ADDENDUM NUMBER 5
for
ADVANCED TREATMENT PROJECT
FORT THOMAS TREATMENT PLANT
NORTHERN KENTUCKY WATER DISTRICT

FROM: CH2M HILL
 TO: Plan Holders of Record

TEMPORARY ASPHALT CONCRETE
PAVEMENT SECTION

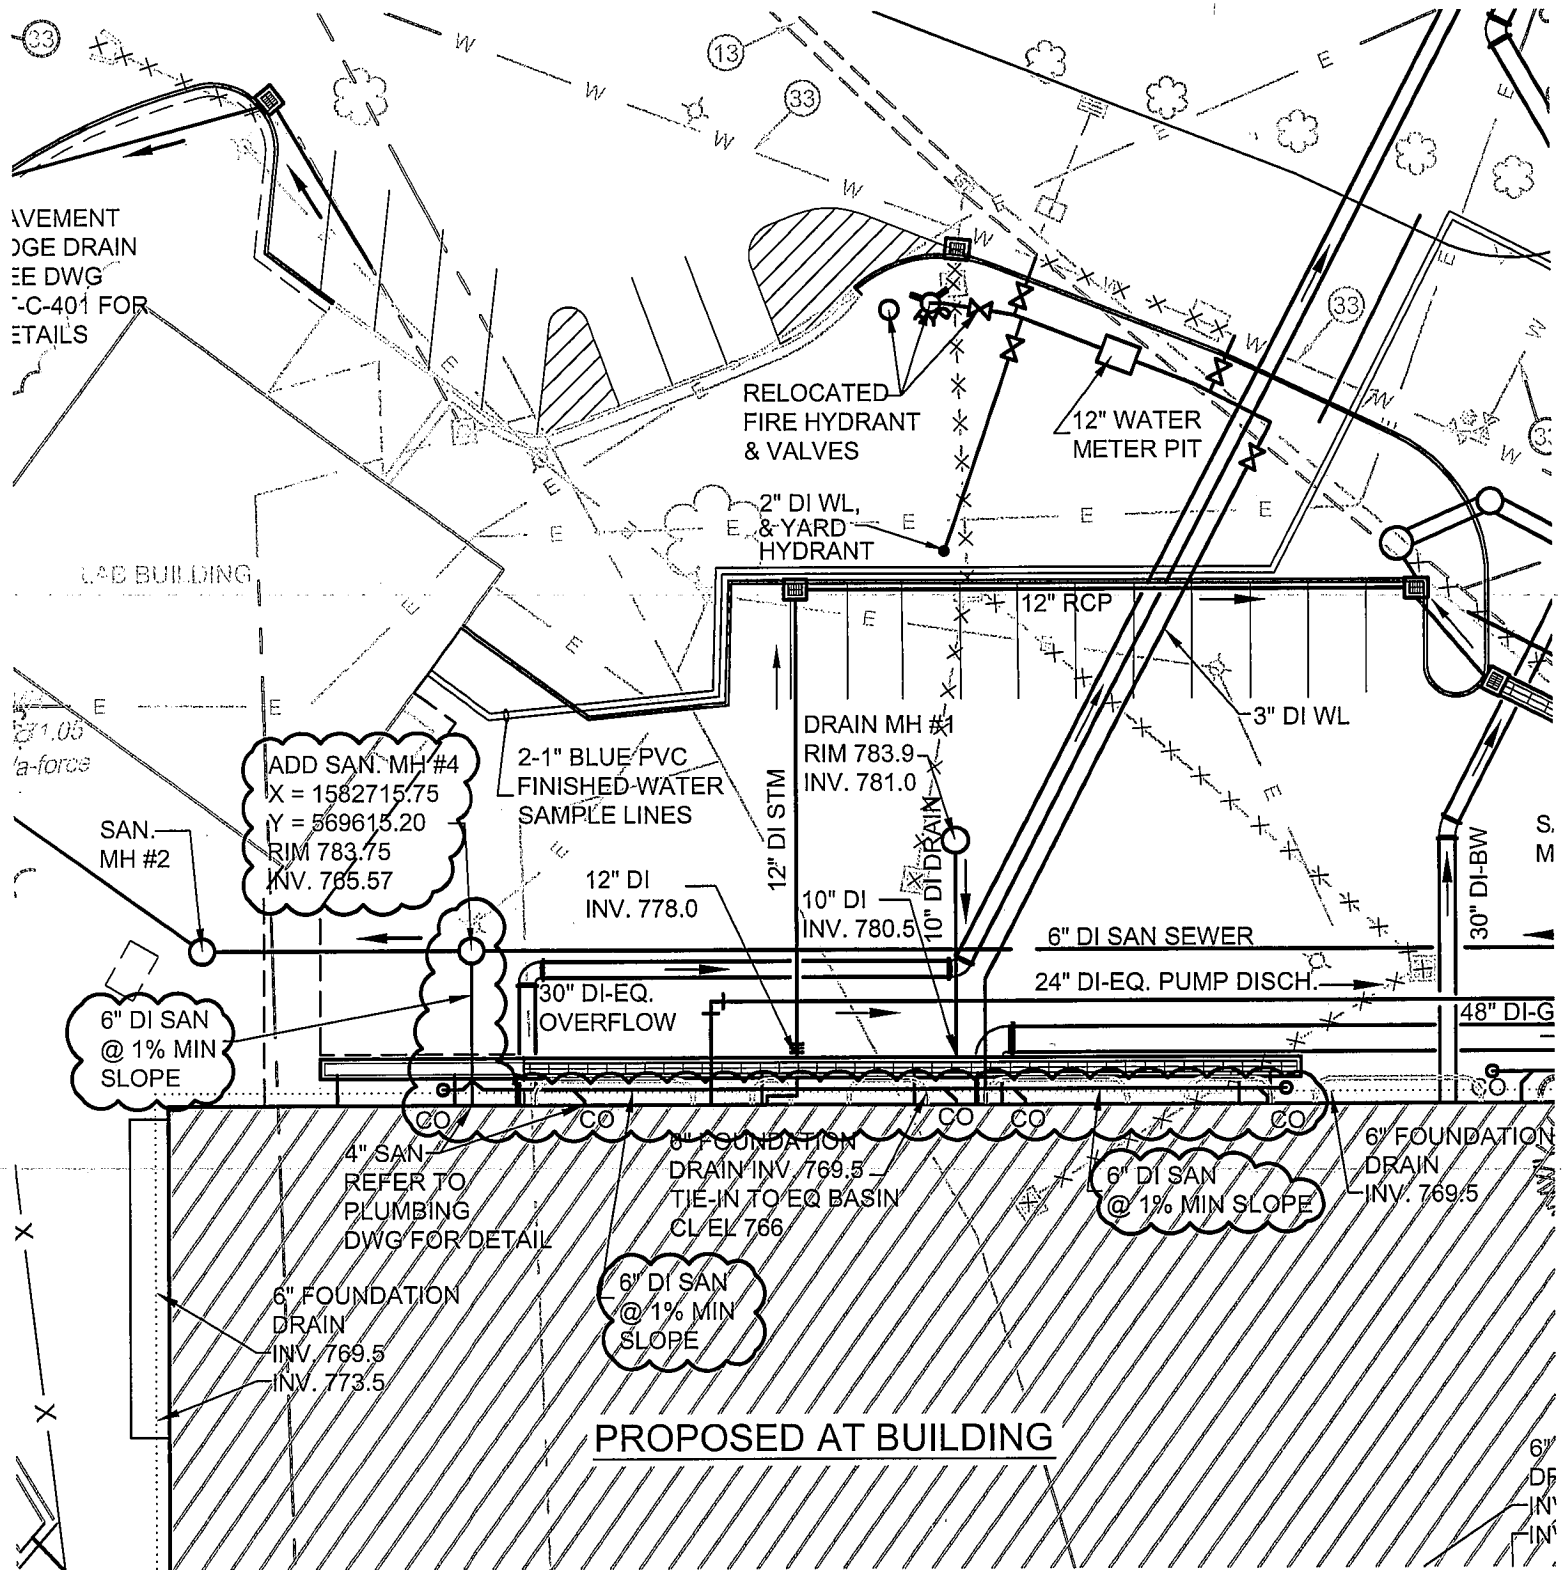
1. Add the following to the CONTACTOR NOTES on this drawing:
 - F. THE WIDTH AND SURFACE ELEVATIONS OF THE TEMPORARY ROAD SHOWN ON THIS DRAWING SHALL CONFORM TO THE WIDTH AND ELEVATIONS OF THE NEW PERMANENT ROAD AS SHOWN ON DRAWING FT-C-103. THE CONSTRUCTION DETAIL FOR THE TEMPORARY ROAD SHALL CONFORM TO THE TEMPORARY PAVING DETAIL ATTACHED TO THIS ADDENDUM.

WATER METER VAULT PLAN & PROFILE

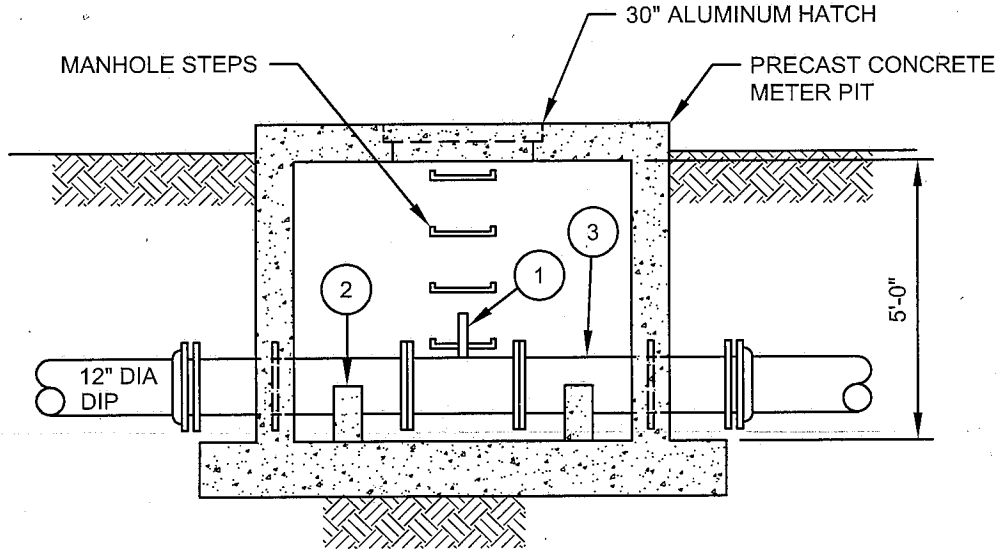
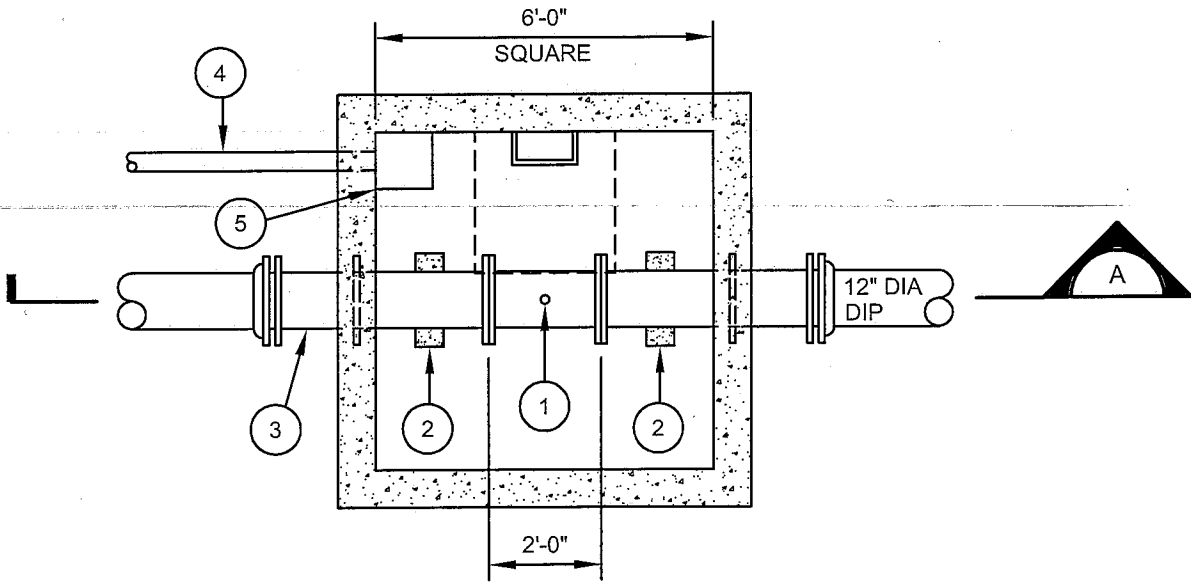
Add the attached WATER METER VAULT PLAN & PROFILE to this Drawing.

CH2MHILL HDR
PLUMBING
AT BUILDING
SECOND FLOOR
NORTH PLAN

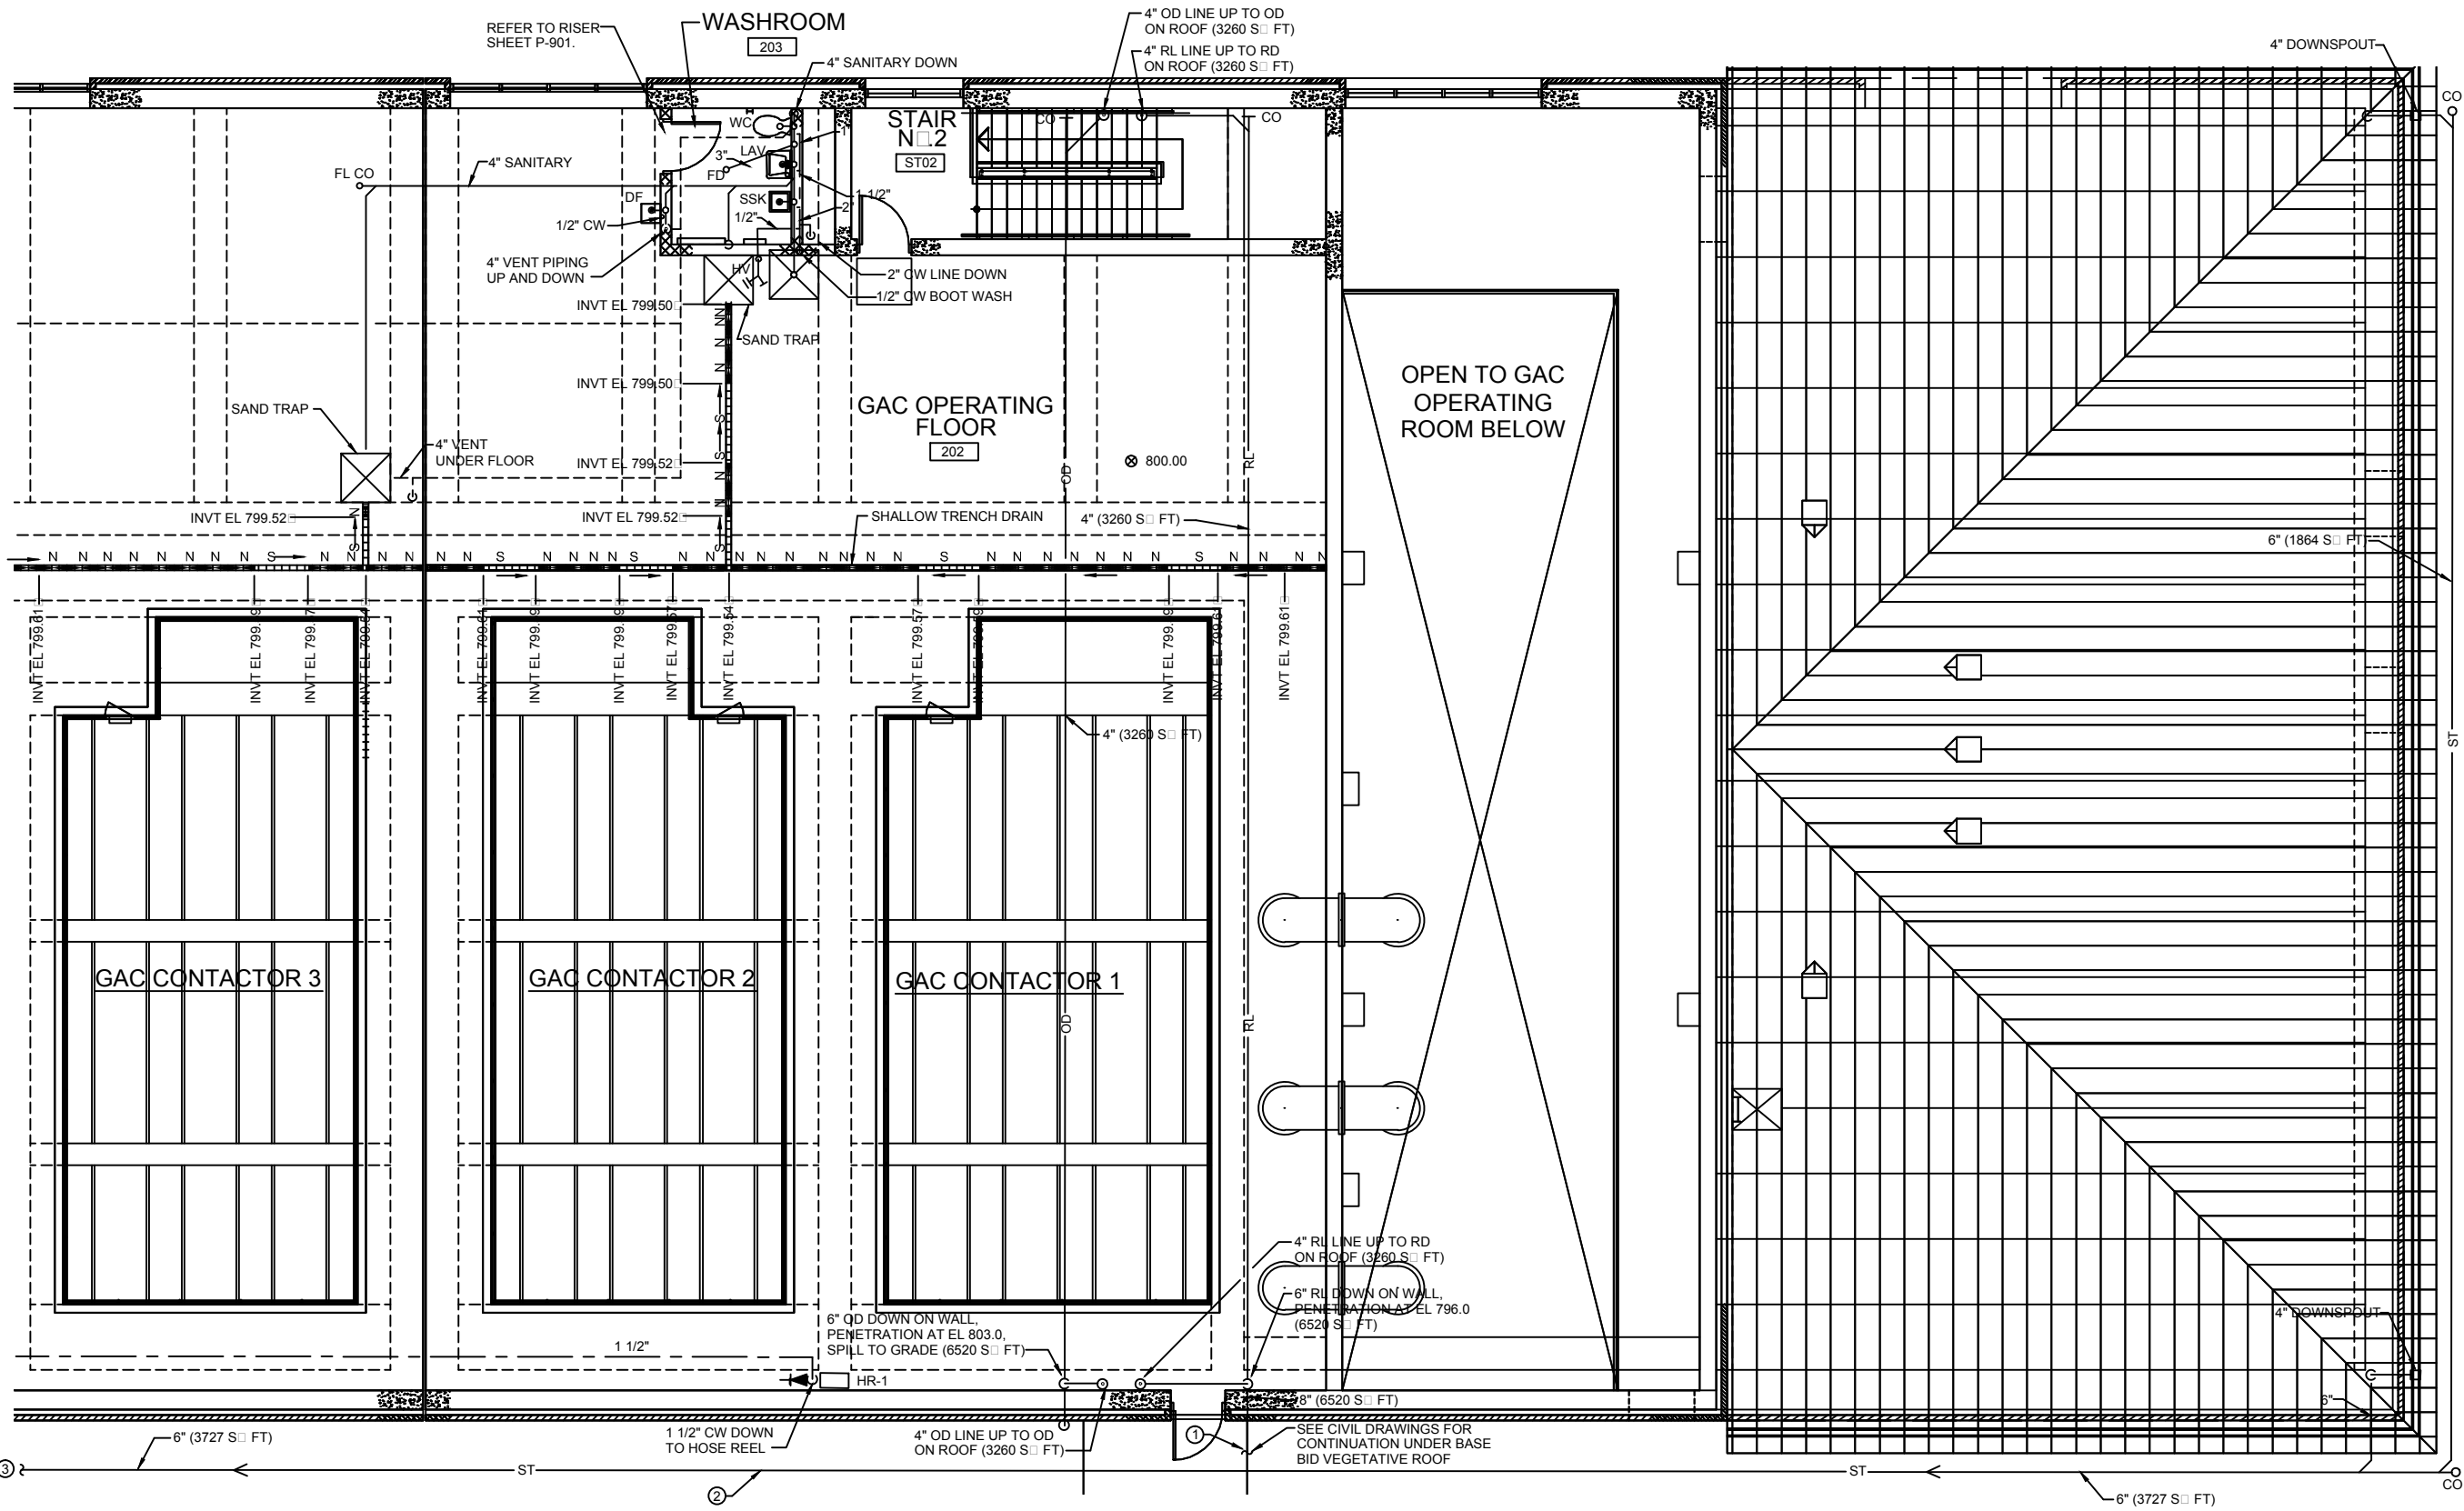
Contractor shall provide a Hose Reel on East wall between GAC Contactors #1 & #2 and water line as required (extended from South Plan (Sheet FT-P-151). Contractor shall provide a ½" Hose Valve (HV) on the wall between Sand Trap & Boot Wash and water line as required. Provide water piping for Hose Reels & Hose Valves as indicated on revised drawing attached to this addendum.

As a clarification the revised drawing is intended to indicate changes related to hose valves, all items in prior addendums related to sheet FT-P-152 remain in effect.

CH2MHILL HDR
PLUMBING
PLUMBING RISER DIAGRAMS

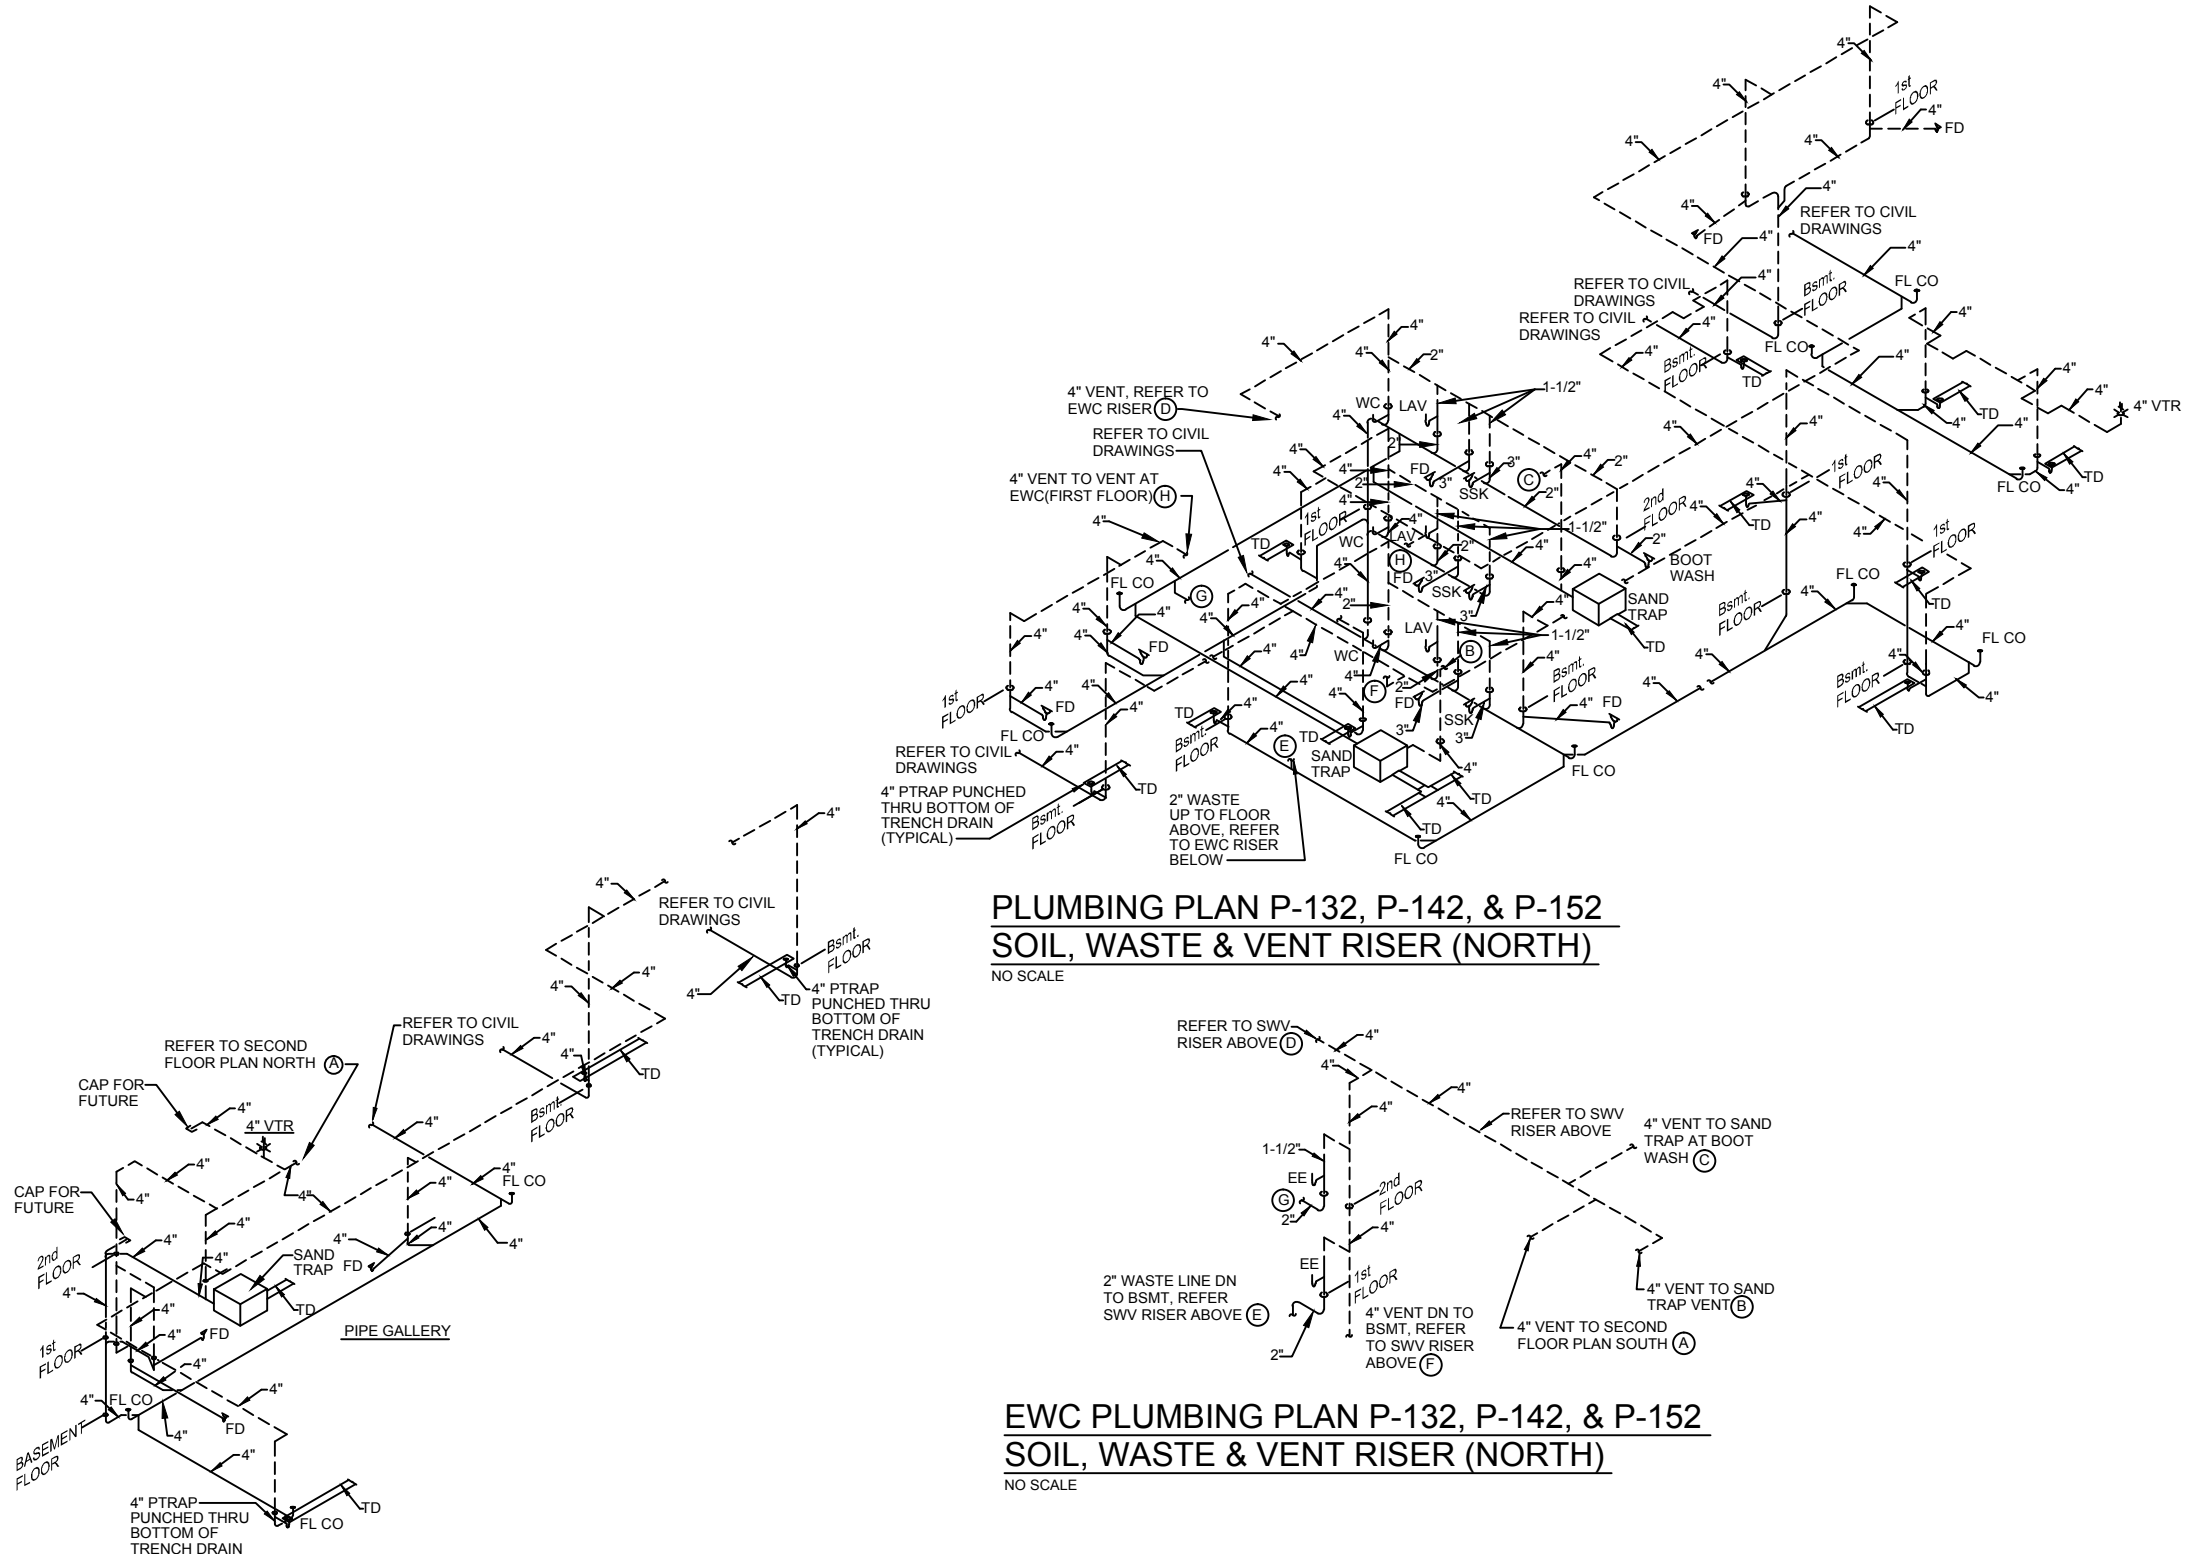
Replace Drawing FT-P-901 with the revised drawing attached to this Addendum.
